REMOVING THE EARTHING PIN FROM THE WELDED TUB CASING ASSEMBLY

From Serial Number 923 xxxxx, the earthing pin has been removed from all welded tub assemblies. Consequently:

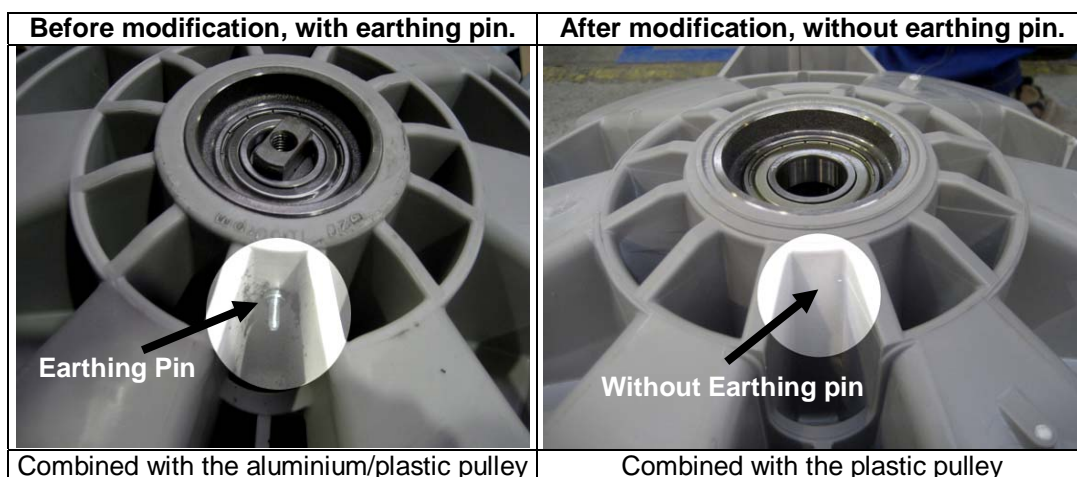
- the relevant wiring is removed and the plastic pulley is used.

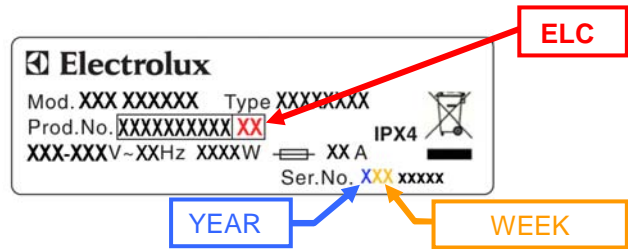
The welded tub casing assembly, complete with rear casing fitted with earthing pin, is supplied as a spare part and can be used on all appliances, as shown in the diagram provided in the table in the paragraph entitled "service information".
